City of Richmond
Urban Development Division

Report to Development Permit Panel

To: Development Permit Panel
From: Joe Erceg
Manager, Development Applications
Date: April 4, 2003
File: DP 02-212896
Re: **Application by D.M.H. Equities Ltd. for a Development Permit at
4591 Garden City Road**

TITLE:
 SITE PLAN

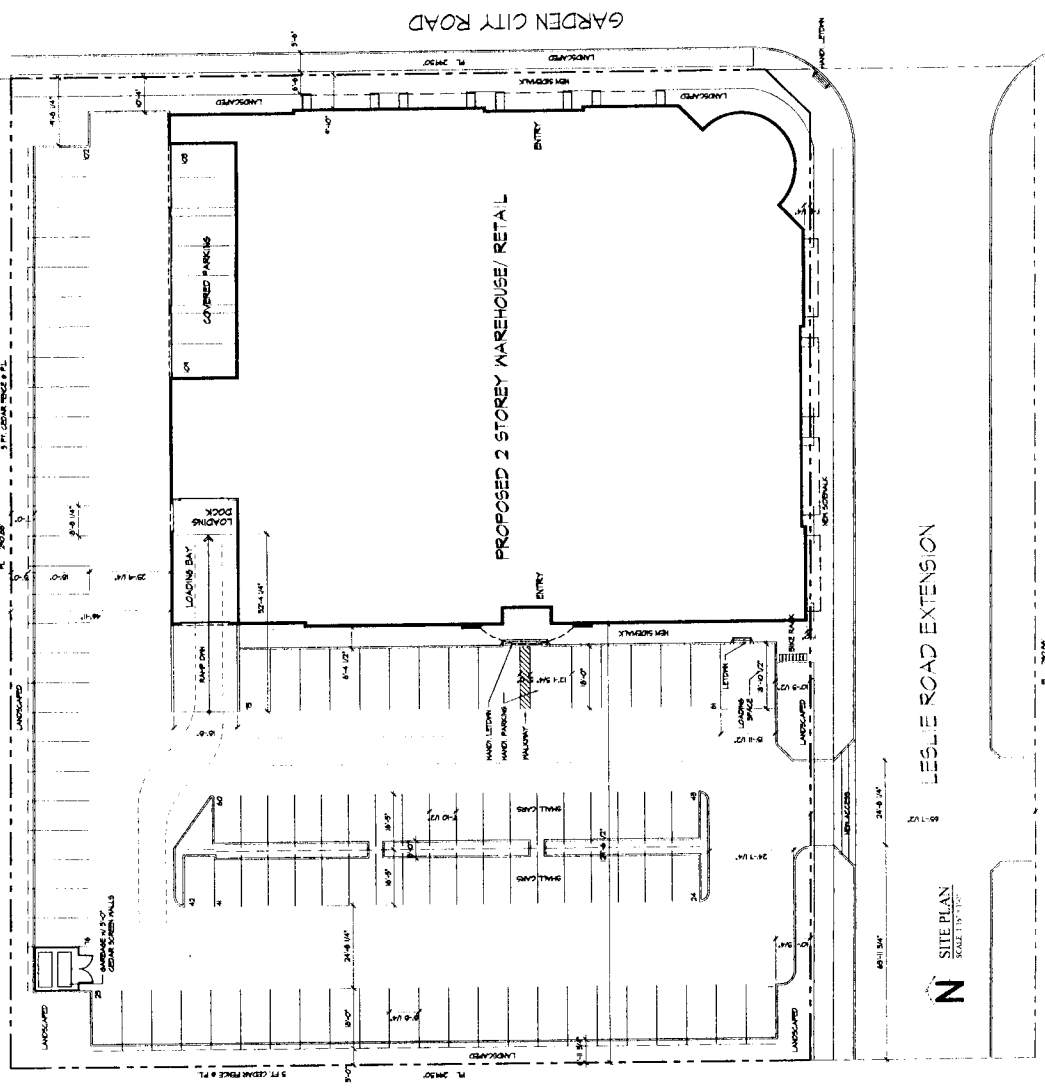
We support the Design Panel comments regarding the architecture. The building design should be further refined to add better details and better quality finish materials. It still looks more like a warehouse than an urban retail building. We are concerned that the main building entrance is poorly located for pedestrian/transit access.

Provide a roof plan with locations of rooftop HVAC equipment, and show how it will be hidden by the architecture (parapets, screens, etc.). The hiding-place "nook" should be eliminated from the covered parking area. The argument that the door swing is preventing elimination of this nook is not valid. The electrical/sprinkler room should be relocated so that there can be openings onto the parking area for surveillance. ***The "nook" has been eliminated, but the electrical room has not been relocated.***

The driveway crossing should be lined up with the west drive-aisle. ***The applicants claim that to do so would cause extra turning movements for the trucks at the loading bay.***

Provide a code analysis. The mezzanine may not be in conformance with the Code. Assure that there are wheelchair let-downs from the handicap parking to the front door. ***The applicants have discussed the Building Code issues with the Building Department and are confident that the issues can be resolved at the Building Permit stage. The handicap let-downs have been added.***

4. Garden City Road elevation not the most "street friendly". Rendering assumes Garden City Road access to parking. ***The applicants have added canopies, a second row of trees, and a store front entry on Garden City Road. The rendering showing car access to Garden City Road is out-of-date.***

LANDSCAPE
 PLAN

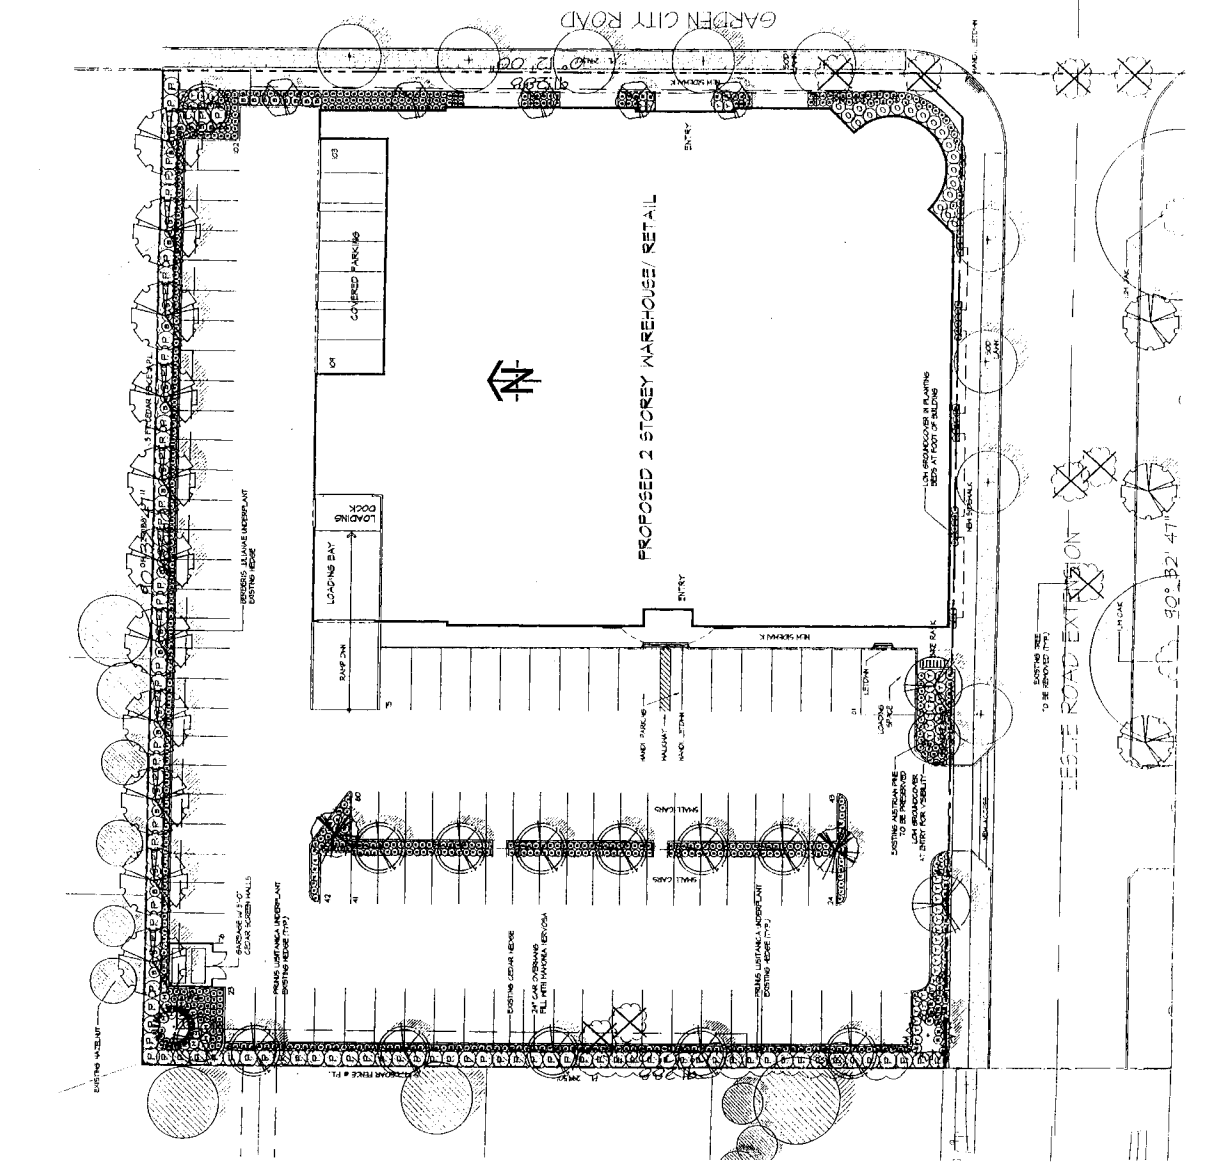
The adjacent residential property should be better screened. There should be more trees in the parking lot and this should be accomplished within the limitations of the parking requirement in the Zoning Bylaw. (We may consider relaxing the aisle-widths to 22 ft.). In addition, see "Analysis of City Centre Guidelines". Existing trees should be fenced immediately since heavy equipment is already on the site. The City will require a Letter of Credit for landscaping prior to forwarding this application to Council. The Letter of Credit will also provide remedy should any of the existing trees be damaged. The drawings should be stamped by a registered architect.

The applicants have increased the landscaping around the perimeter, which now consists of a 5 ft. cedar fence, a Portugese Laurel hedge, and Beech trees. There are now 13 trees proposed in the parking lot.

- Social and cultural features should be made plentiful, accessible, and of higher quality.
- Natural, built, and human heritage should be retained, enhanced, and celebrated. **Provide tree-protection fencing immediately. Show tree-protection measures on the landscape plans. An arbourist should be retained to monitor the existing trees during construction. The applicants removed all of the trees on the site prior to pre-loading, except for a Pine tree and the Oak trees on the Leslie Road. Replacement trees at 10 cm caliper are shown on the landscape plan.**
